Z-32
(2016)

ZONING SITE PLAN
FOR
CONWAY COMMONS
COBB COUNTY, GEORGIA

PETITION NO: Z-32
HEARING DATE (PC): 04-01-16
HEARING DATE (BOC): 04-19-16
PRESENT ZONING: R-15, O&I

ZONING COMMENTS:

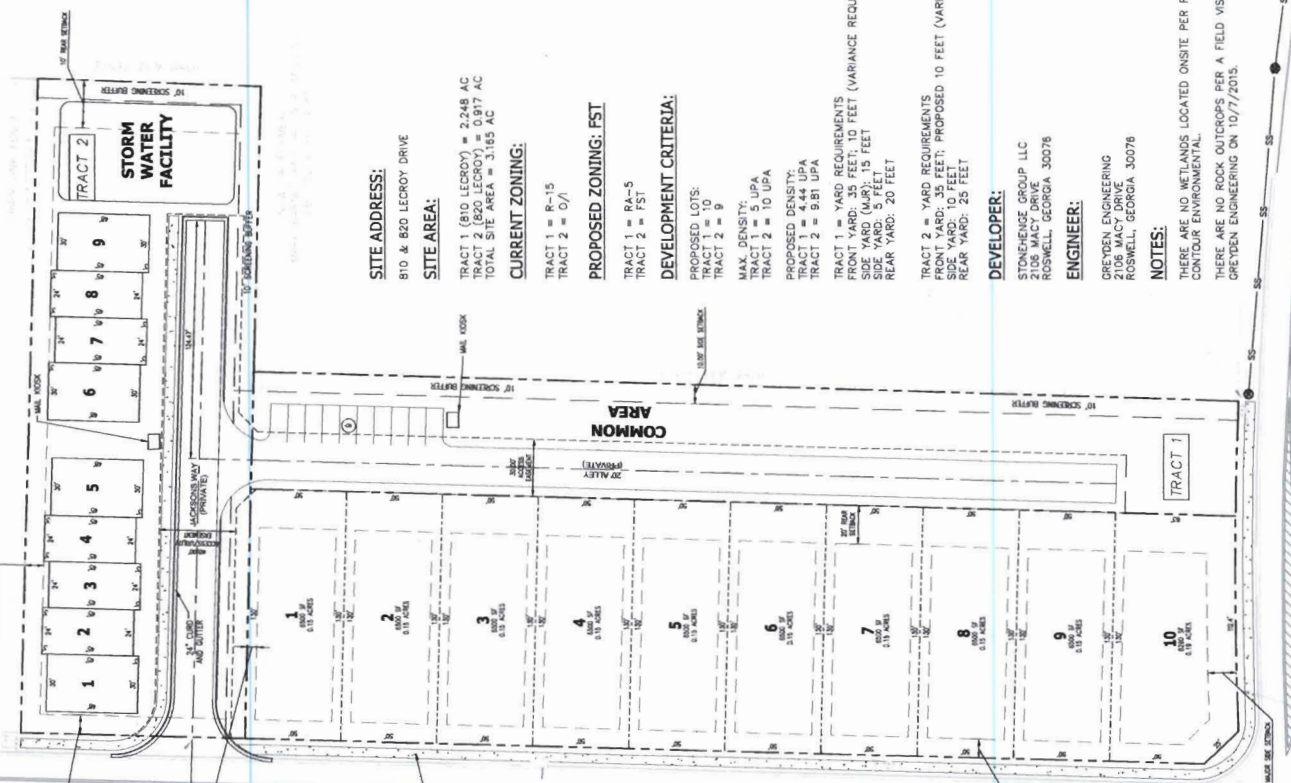
- Guest Parking be implemented to facilitate the roadways remain clear for emergency vehicles
- No physical boundaries along Lecroy Dr otherwise the Private Alley will require a fire department turn-around meeting the specifications listed below

Dead-end access roads in excess of 150 feet shall be provided with a turn-around (IFC 503.2.5 2006 Edition). Cul-de-sac with or without an island: minimum 60-foot radius to outside curb, measured to inside of curb and a minimum lane width = 24 feet (Cobb County Development Standard 401.09). Single-Family cul-de-sac without island: 38-foot outside radius with island reverts to commercial dimensions. Hammerhead turn-around: total of 110 feet needed (45 feet + 20 feet wide roadway + 45 feet).

GUEST PARKING: When projects contemplate less than 20 foot separation between units, guest parking shall be provided or the streets shall be labeled as a fire lane.

- Provide comprehensive hydrology/stormwater controls to include development of out parcels.
- Submit all proposed site improvements to Plan Review.
- Any **spring activity** uncovered must be addressed by a qualified geotechnical engineer (PE).
- Structural fill _____ must be placed under the direction of a qualified registered Georgia geotechnical engineer (PE).
- Existing facility.
- Project must comply with the Water Quality requirements of the CWA-NPDES-NPS Permit and County Water Quality Ordinance.
- Water Quality/Quantity contributions of the existing lake/pond on site must be continued as baseline conditions into proposed project.
- Calculate and provide % impervious of project site.
- Revisit design; reduce pavement area to reduce runoff and pollution.

- No Stormwater controls shown _____
- Copy of survey is not current – Additional comments may be forthcoming when current site conditions are exposed.
- No site improvements showing on exhibit.

2. The existing channel conveyance through the Mulling property is not well-defined and has limited capacity. Site discharges must be limited to the existing conveyance capacity.

3. As mentioned in the Downstream Conditions Comments, Mulling’s Lake is located approximately 450 downstream of the site. Elevated erosion control measures will be required to protect the lake. A pre- and post-development sediment survey will be required to document any adverse sediment impact to the lake during development.

Robinson Road is classified as a major collector and according to the available information the existing right-of-way does not meet the minimum requirements for this classification.

Lecroy Drive is classified as a local and according to the available information the existing right-of-way does not meet the minimum requirements for this classification.

Recommend applicant consider entering into a development agreement pursuant of O.C.G.A. 36-71-13 for dedication of the following system improvements to mitigate traffic concerns: a) donation of right-of-way on the north side of Robinson Road, a minimum of 40' from the roadway centerline.

Recommend applicant consider entering into a development agreement pursuant of O.C.G.A. 36-71-13 for dedication of the following system improvements to mitigate traffic concerns: a) donation of right-of-way on the east side of Lecroy Drive, a minimum of 25' from the roadway centerline.

Recommend sidewalk along the Robinson Road frontage.

Recommend sidewalk along the Lecroy Drive frontage.

Recommend deceleration lane for the Lecroy Drive access point.

Recommend a no access easement along the Robinson Road frontage.
